U. S. NUCLEAR REGULATORY COMMISSION
REGION I

DOCKET/REPORT NCS: 50-271/95-14
LICENSEE: Vermont Yankee Nuclear Power Corporation
Brattleboro, Vermont 05301
FACILITY: Vermont Yankee Nuclear Power Station
DATES: June 26-30, 1995
INSPECTORS: L. Privity, Senior Reactor Engineer, RI
M. Schlyamberg, Contractor

Summary: Good management oversight of service water (SW) issues was evident. Sound corrective actions, consistent with Generic Letter (GL) 89-13, "Service Water System Problems Affecting Safety-Related Equipment," were being implemented regarding the licensee's SW self-assessment previously performed in February 1994. Good progress was made in resolving longstanding concerns regarding SW system surveillance testing. An extensive SW hydraulic model was developed, including validation and considerations for component degradation. A SW system design basis document was developed with an appropriate level of detail to define system design requirements. Comprehensive measures have been taken concerning heat exchanger testing, and a novel performance monitoring method was utilized which enables quick determination (by operating personnel), comparing test results against pre-established p

Figure 1 - Actual to Maximum Delta T Performance Curves

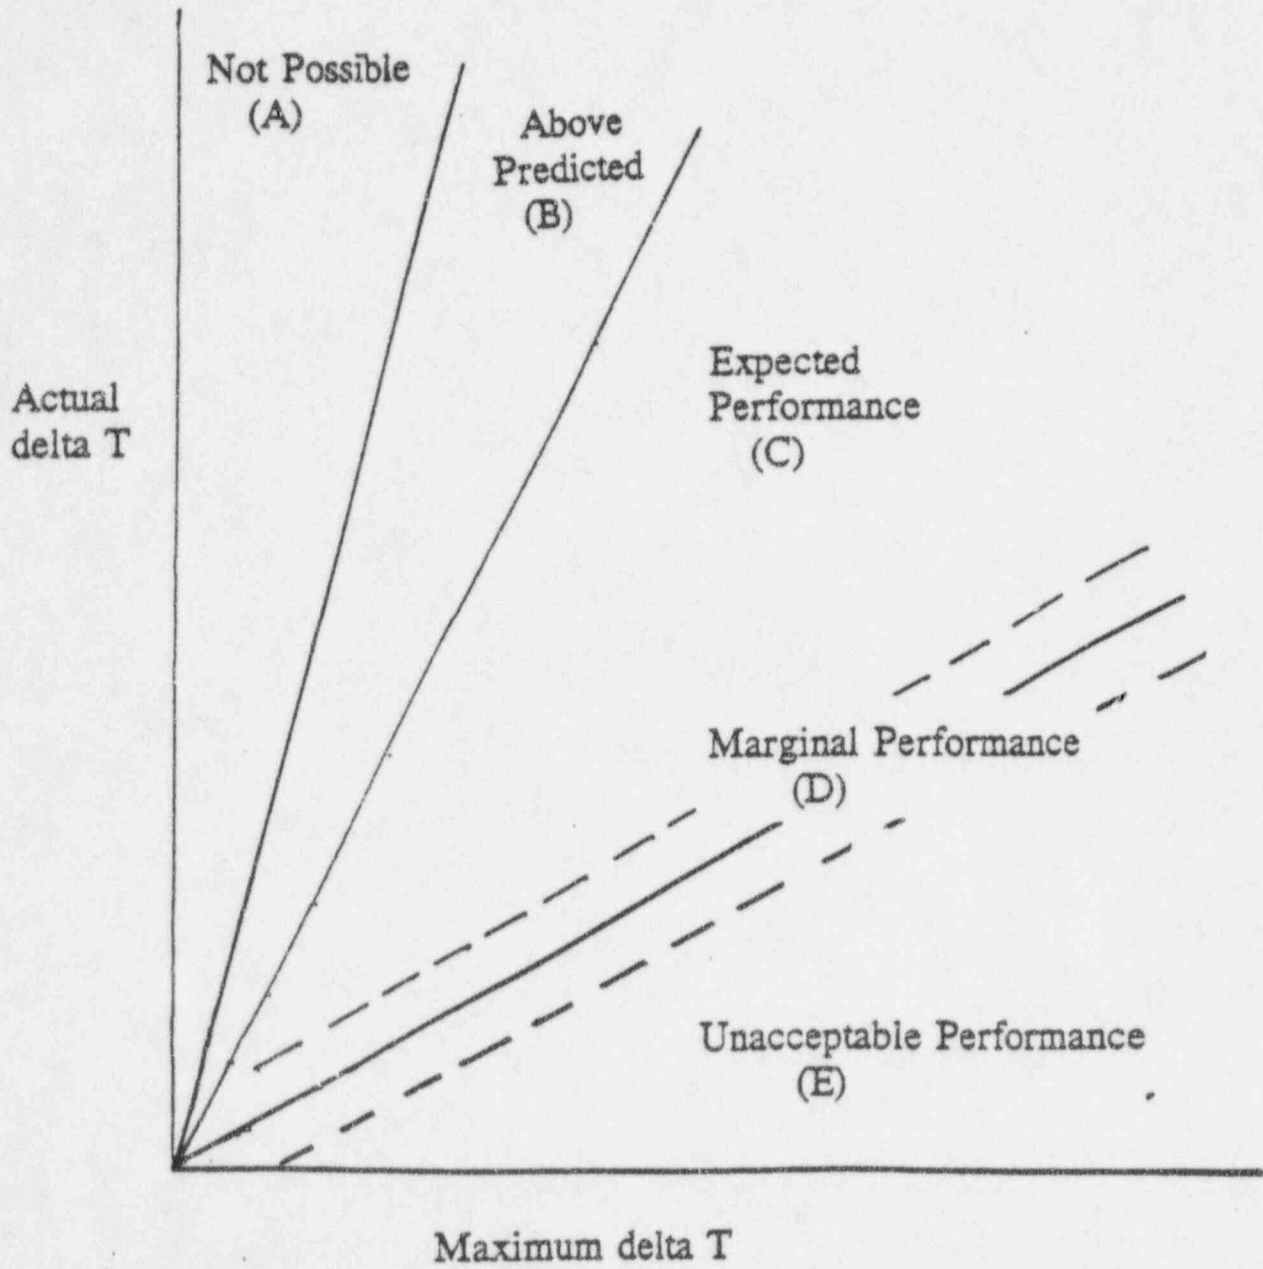
These curves establish five performance regions and were developed for the RHR HX in Calculation No. VYC-1328, performed by Yankee Atomic, using a combination of the "Heat Transfer" and "Temperature Effectiveness" methods as described in EPRI NP-7552, "Heat Exchanger Performance Monitoring Guidelines." The calculation was clearly presented with the assumptions and references used. Figures 1 and 2, which were extracted from the aforementioned technical paper, are attached to this report to illustrate the Delta Temperature (ΔT) method.

Use of the ΔT method is a departure from conventional engineering techniques, which calculate other parameters (e.g., heat transfer coefficients and fouling factors) to evaluate HX performance. The ΔT method compares the Maximum Delta Temperature ($T_{\text{process hot}} - T_{\text{sw cold}}$) to the Actual Delta Temperature ($T_{\text{sw hot}} - T_{\text{sw cold}}$). The results of the heat exchanger tests permit an immediate graphical plot by plant operating personnel of the actual HX performance in relation to the design required performance, which makes this method "user friendly." Significant differences in temperatures and flow rates will require development of a corresponding set of curves. Although the licensee

considered that the test results can also be easily trended, the trending capability was not apparent to the inspectors, since the dT method provided a qualitative and quantitative analysis of heat exchanger performance, which could be subjective. The use of the dT method to assess the HX test results addressed most of the points in the SW self-assessment.

The licensee used the dT method for the evaluating the performance of the RHR and the SFPCS HXs. The inspector reviewed the test results given in the respective operating procedures (OP 4124 and OP 4179) and observed that satisfactory results were obtained. The temperature data placed the HXs in the acceptable performance region (Region C) in the graphical plot. The inspectors considered the dT method to be a good, novel approach which facilitated a quick and easy assessment of heat exchanger performance. Furthermore, the acceptance criteria include clearly defined instrument uncertainty regions. However, the capability to use this method for trending heat exchanger performance was not yet apparent.
